**RE:   Completeness Responses  
      Vigo Coal Operating Co., LLC.  
      Friendsville Mine  
      Permit 330 & 458 – SIG. REV.**

Please accept the following material for completeness responses for Vigo Coal's 330 & 458 Permit – SIG. REVISION as outlined below.

Completeness Revisions - Sig. Revision to add a fine course refuse impoundment and to add developed water to the reclamation plan.

**Slurry Impoundment 4**

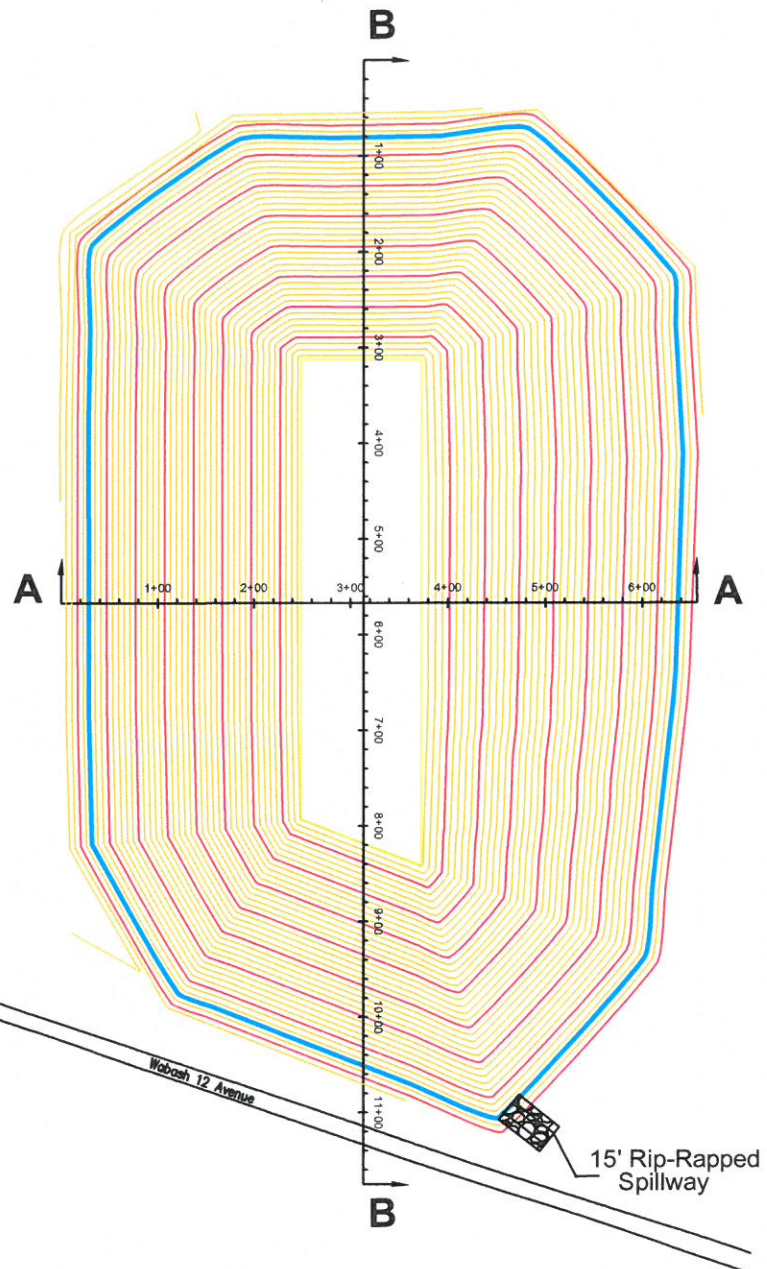
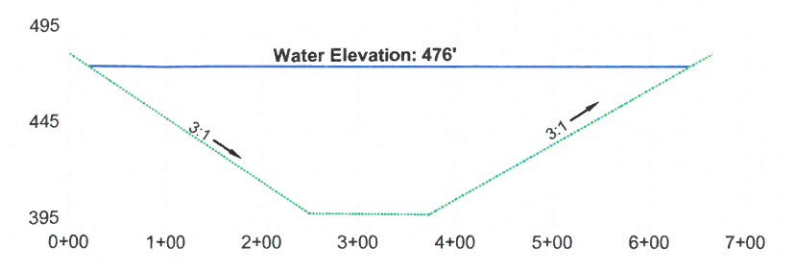
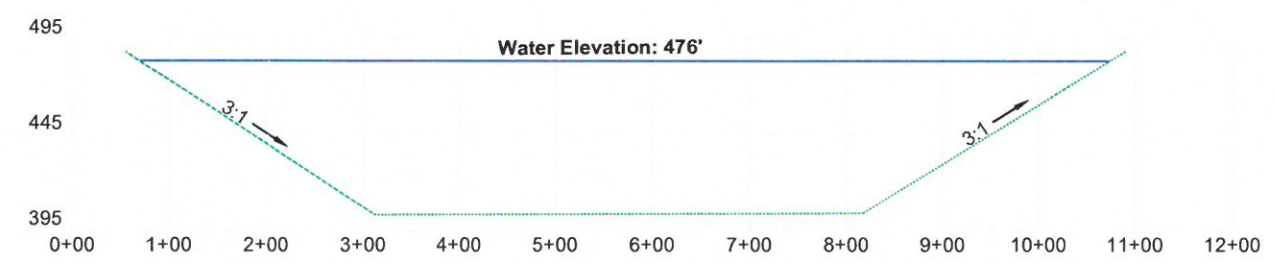
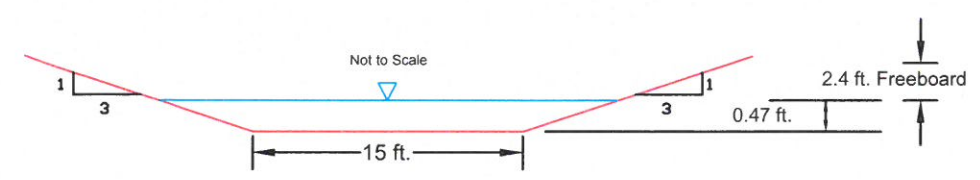
3.     The applicant provided Attachment 9.4.1 but, the applicant did not include the question of this part of the application. Pursuant 62 Ill. Adm. Code 1780.25(a) and (c), the applicant shall include the question 9.4 and its respective answer. Specifically, details that have not been included in the application and shall be addressed are: water level of the final pool elevation of Slurry Pond #4, relationship of the refuse disposal area to the post-mining land use, sampling plan of refuse material for neutralization material rates and description of final drainage configuration of the impoundment. **Part 9.4 was added to the application. Final pool elevation was added to**

**Attachment 3.12.2.1 and is also shown on Attachment 5.4.1.2. Attachment 9.4.1 was revised to address neutralization rates. None are proposed, water cover will be sufficient to prevent oxidation. The final configuration for the impoundment can be found on Attachments 3.12.2.1 and 5.4.1.2**
